Vermont Yankee Nuclear Power Station

Technical Specification Proposed Change No. 257

Calculation VYC-0693A – APRM Neutron Monitoring Trip Loops

FIGURE 2.1-1

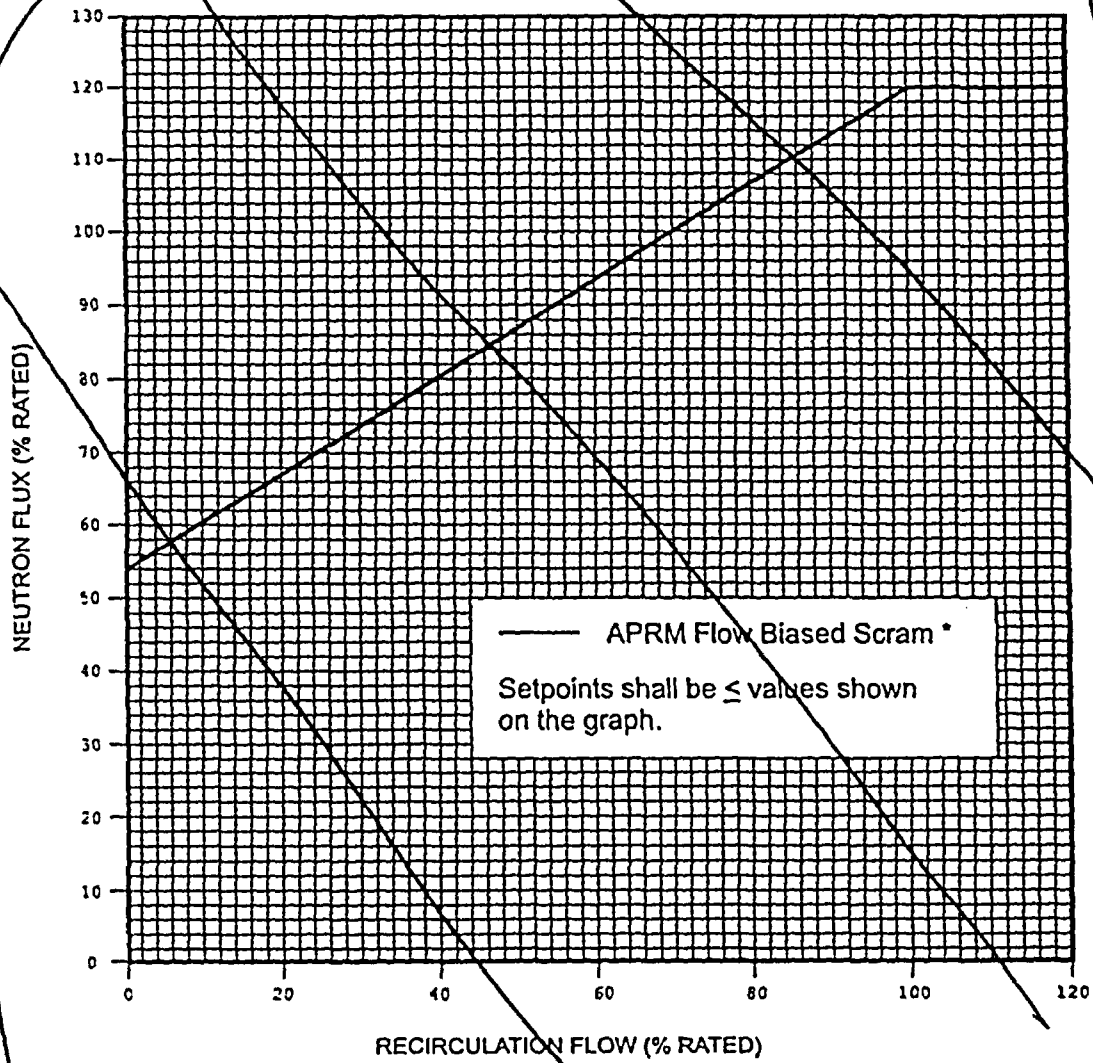
The change in the neutron flux trip setting algorithm is supported by the ARTS/MELLLA analysis provided as part of Proposed Change No. 257. The deletion of reference to TS Figure 2.1.1 is discussed below.

### TS Figure 2.1.1 (current page 11)

TS Figure 2.1.1 does not provide any requirement not included in the stated algorithms for this function. Because the figure is redundant, it can be eliminated from TS without any change in technical requirements. In addition, elimination of this figure is consistent with Standard Technical Specifications.
